Re: Florida Power & Light Company
Proposed Turkey Point Units 6 and 7
Docket Nos. 52-040 and 52-041
Response to NRC Request for Additional Information Letter No. 58 (eRAI 6434) - Concerning Implementation of Fukushima Near-Term Task Force Recommendations

NRC RAI Letter No. PTN-RAI-LTR-058 Dated May 1, 2012

NRC RAI Number: 01.05-1 (eRAI 6434)

Figure 4: CEUS Hard Rock Hazard Results for 0.5 Hz Spectral Acceleration

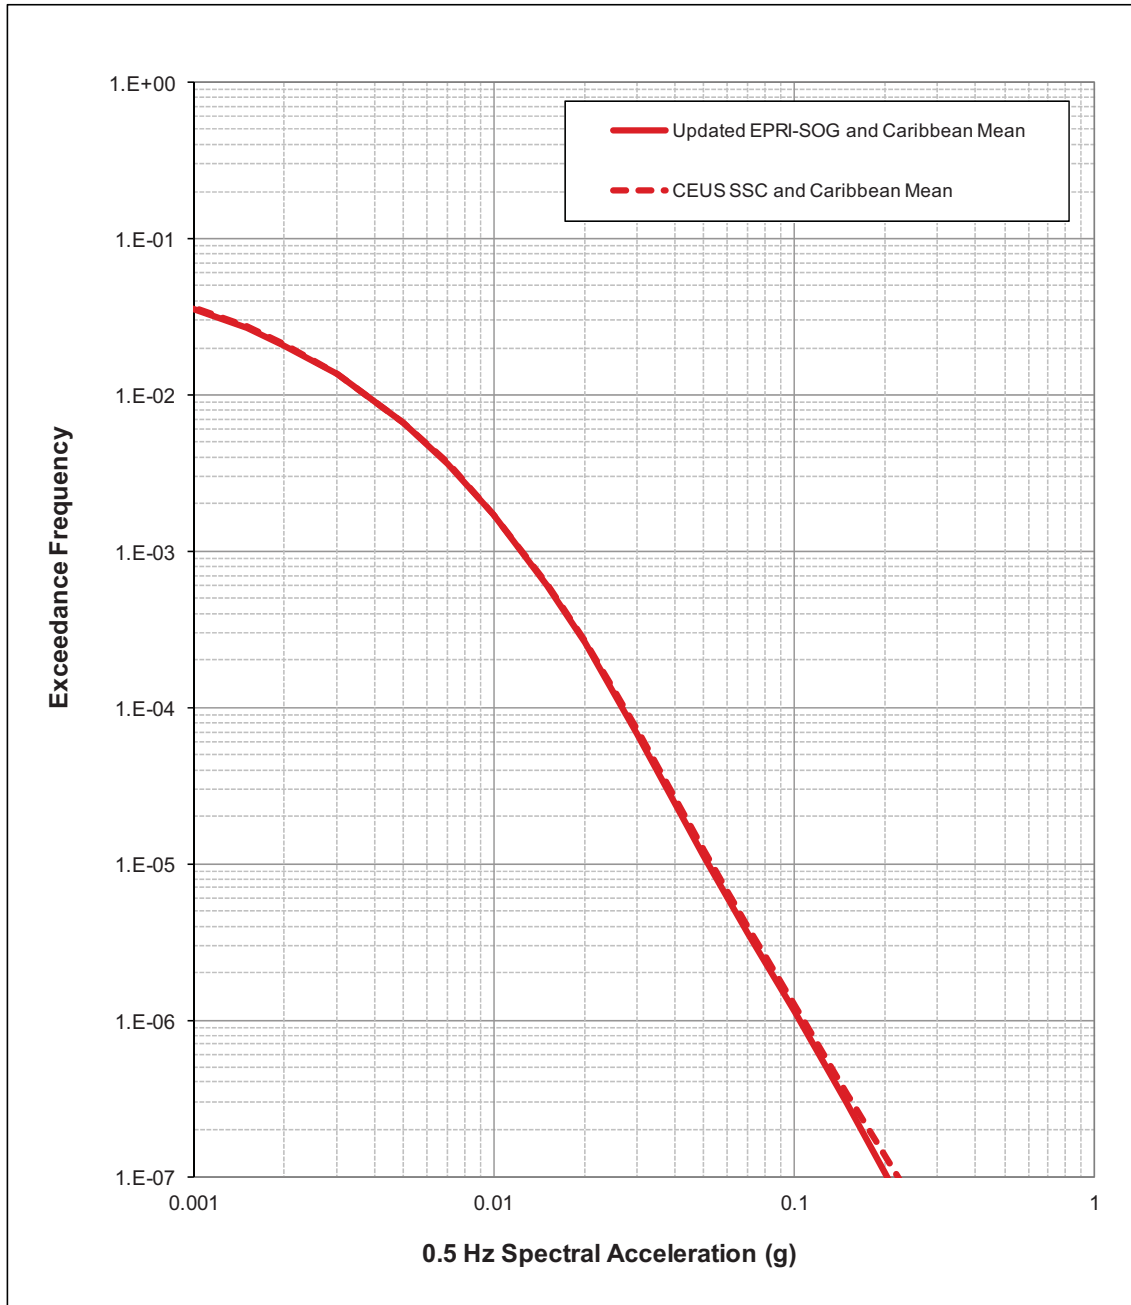
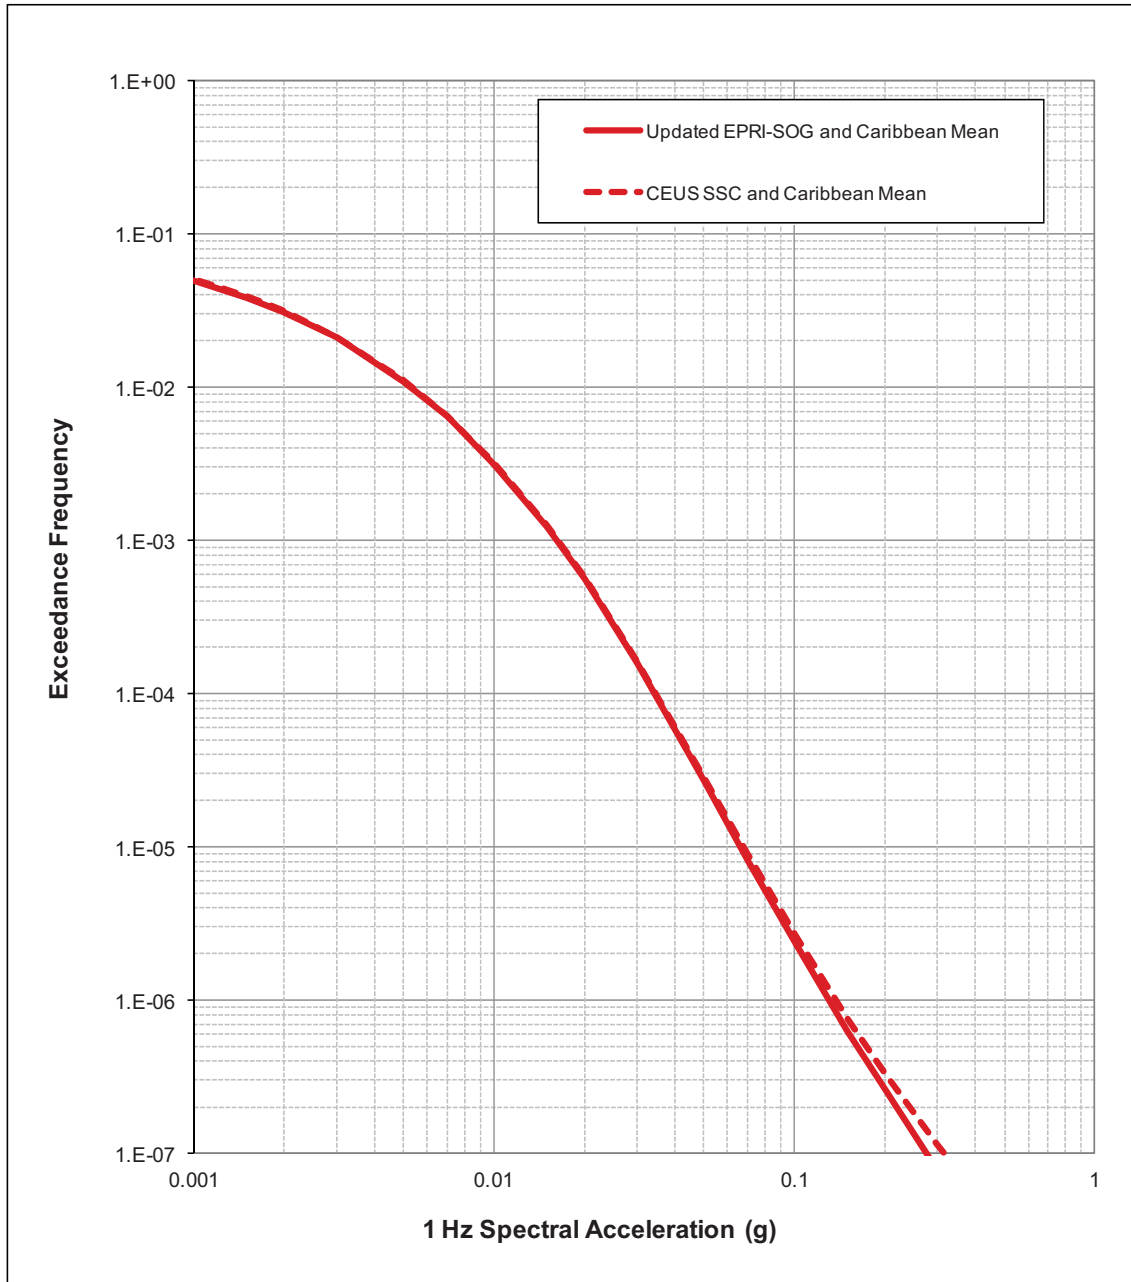
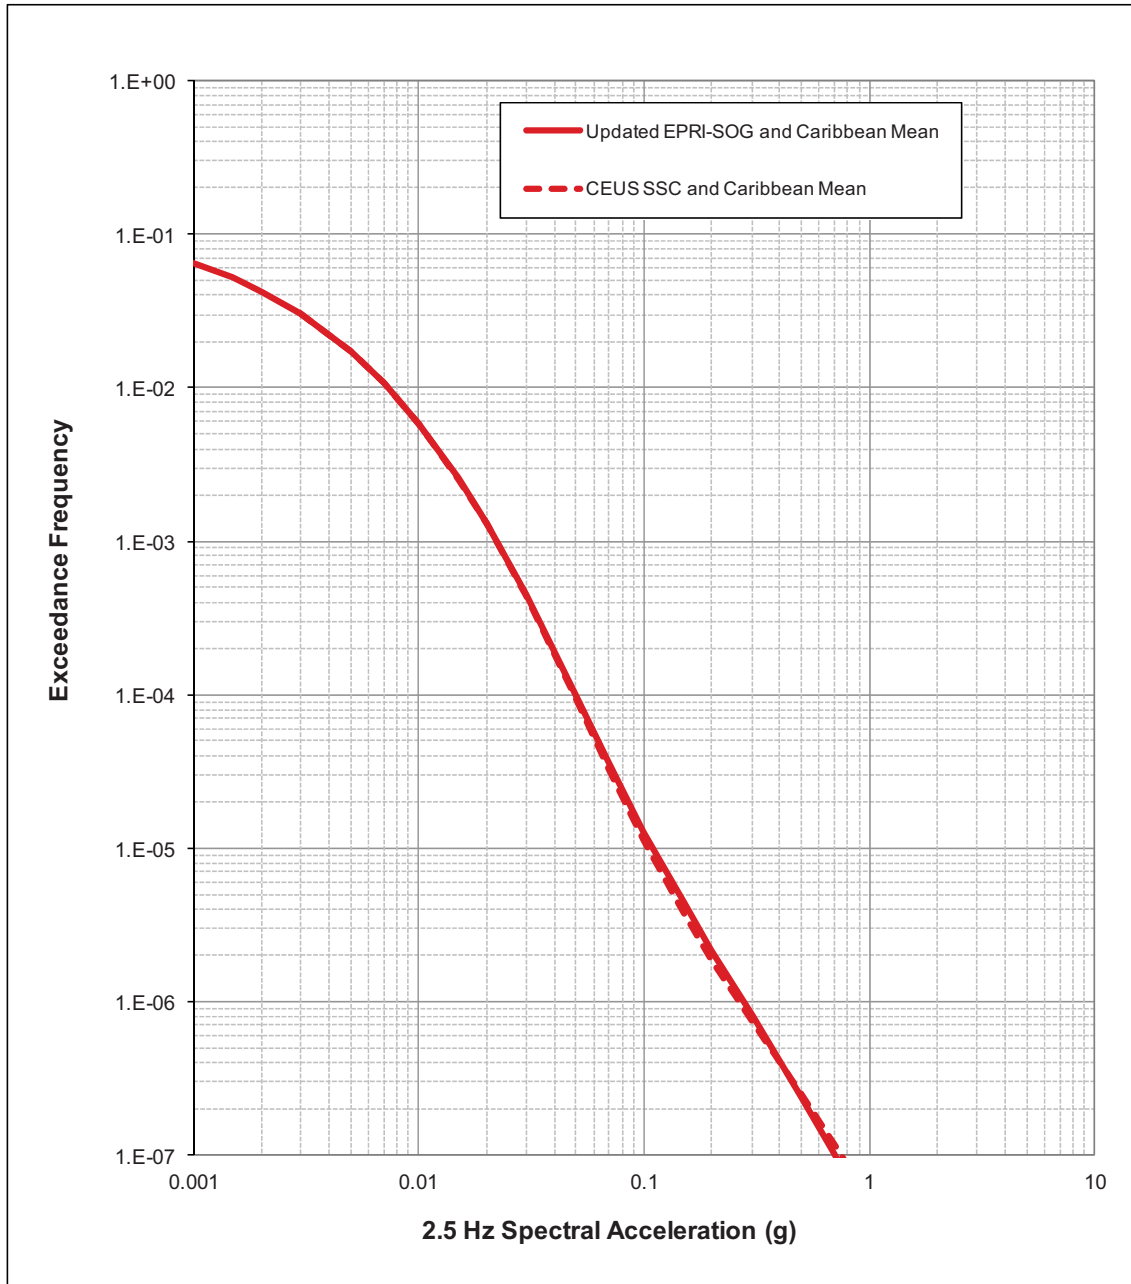
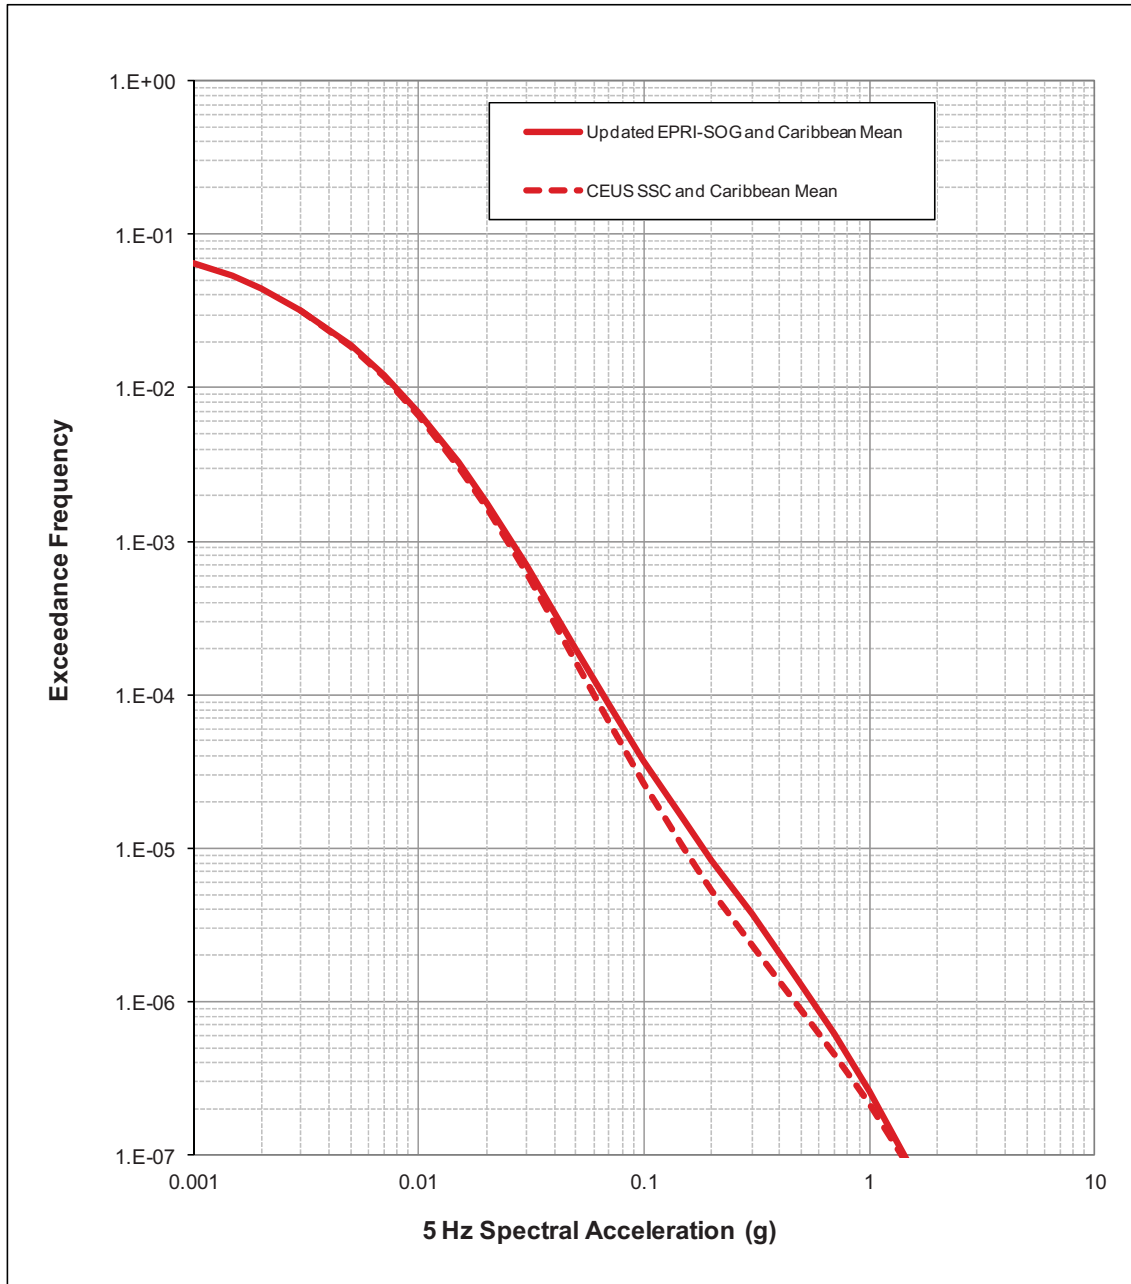
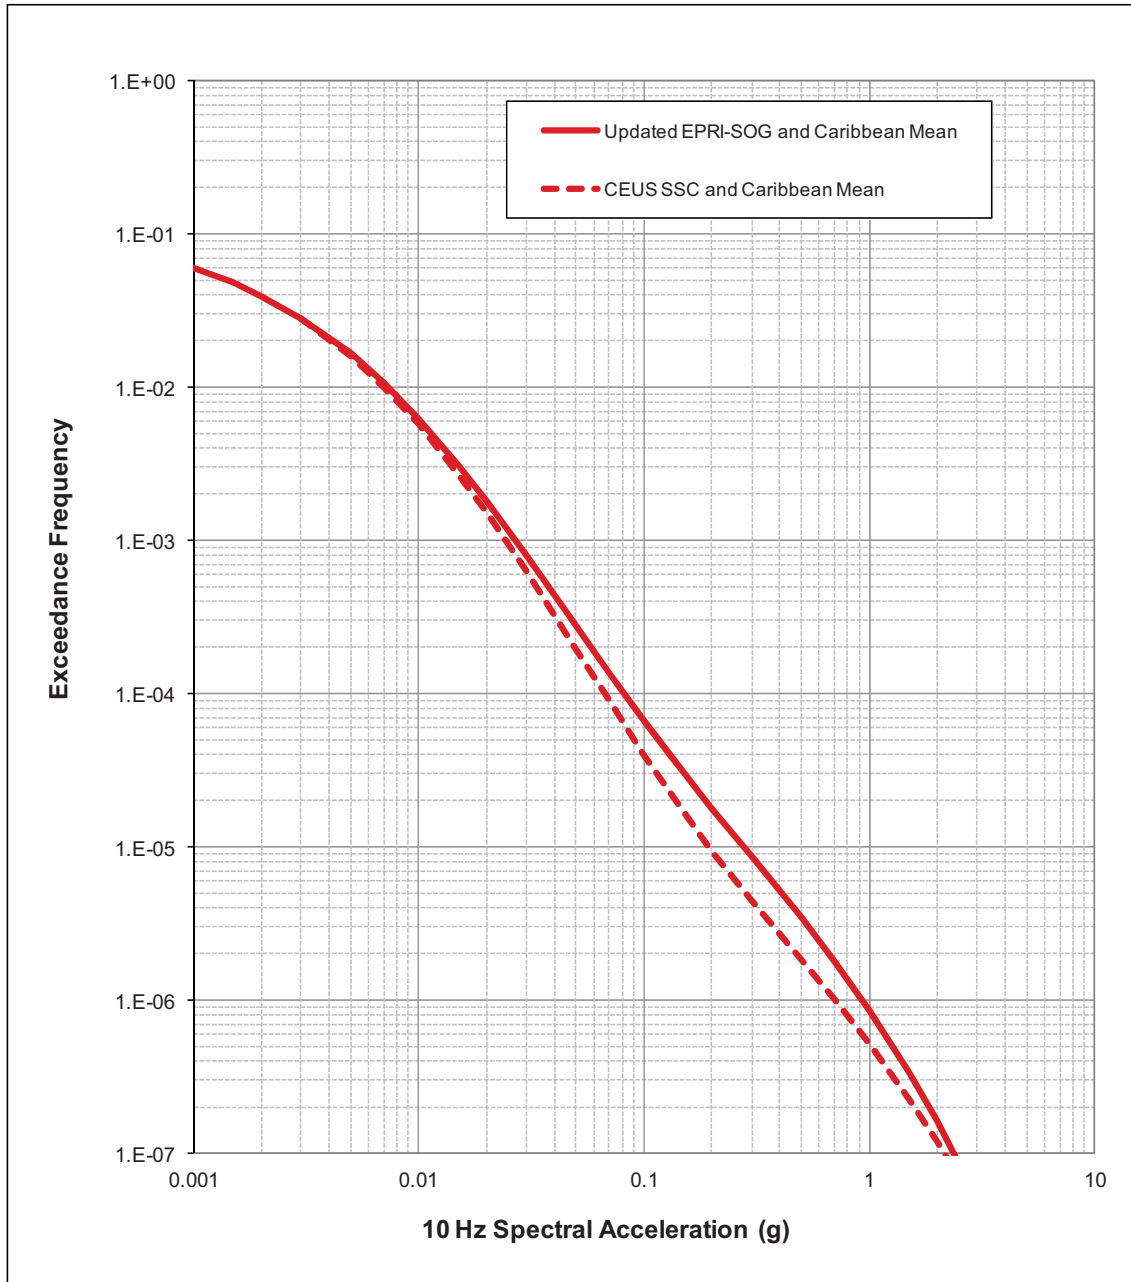
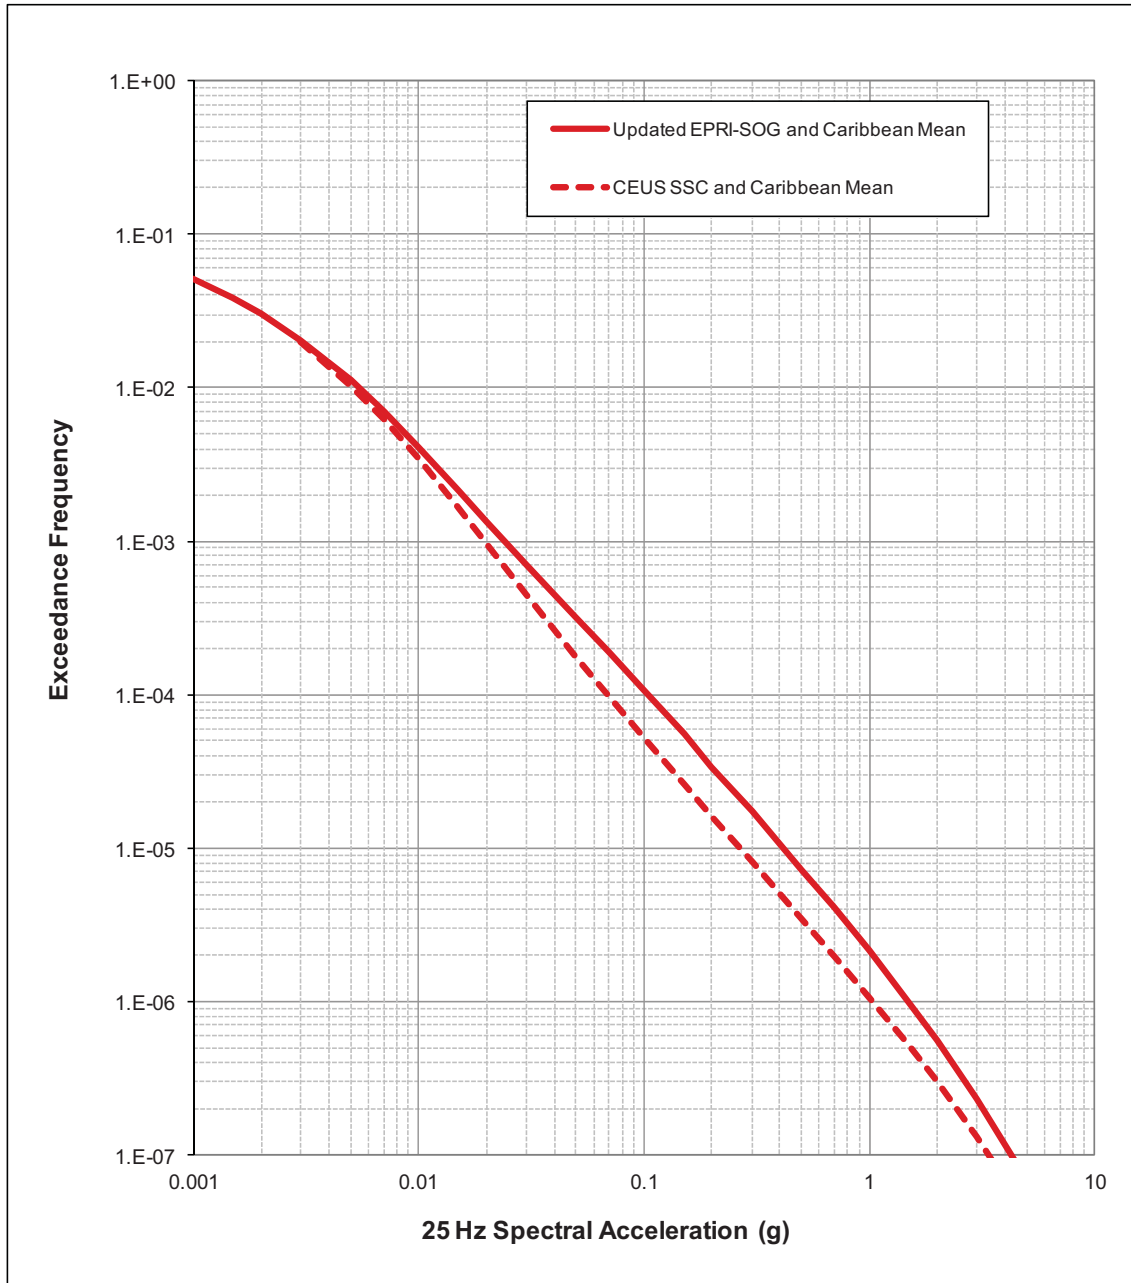
- a) Evaluate the potential impacts of the newly released CEUS SSC model, with potential local and regional refinements as identified in the CEUS SSC model, on the seismic hazard curves and the site-specific ground motion response spectra (GMRS)/foundation input response spectra (FIRS). For re-calculation of the PSHA, please follow either the cumulative absolute velocity (CAV) filter or minimum magnitude specifications outlined in Attachment 1 to Seismic Enclosure 1 of the March 12, 2012 letter "Request for information pursuant to Title 10 of the *Code of Federal Regulations* 50.54(f) regarding Recommendations 2.1, 2.3, and 9.3, of the near-term task force review of insights from the Fukushima Dai-Ichi accident." (ML12053A340).
- b) Modify the site-specific GMRS and FIRS if you determine changes are necessary given the evaluation performed in part a) above.

Figures 4 through 10 compare the total mean hazard from the updated EPRI-SOG plus Caribbean sources presented in Subsection 2.5.2.4 and Table 2.5.2-223 of the FSAR to the total mean hazard from the CEUS SSC model plus Caribbean sources. For structural frequencies of 2.5 Hz and higher, the total hazard computed using the CEUS SSC sources is lower than that computed using the updated EPRI-SOG sources in the important annual exceedance frequency range of $1\text{E-}04$ to $1\text{E-}06$. For structural frequencies of 0.5 and 1 Hz, the total hazard computed using the CEUS SSC model sources is higher by about 3 percent at an exceedance frequency of $1\text{E-}04$ and by about 11 percent at an exceedance frequency of $1\text{E-}06$. These differences in hazard for structural frequencies of 0.5 and 1 Hz are less than the suggested tolerances for hazard accuracy presented in Chapter 9 of NUREG-2115 (Reference 2).
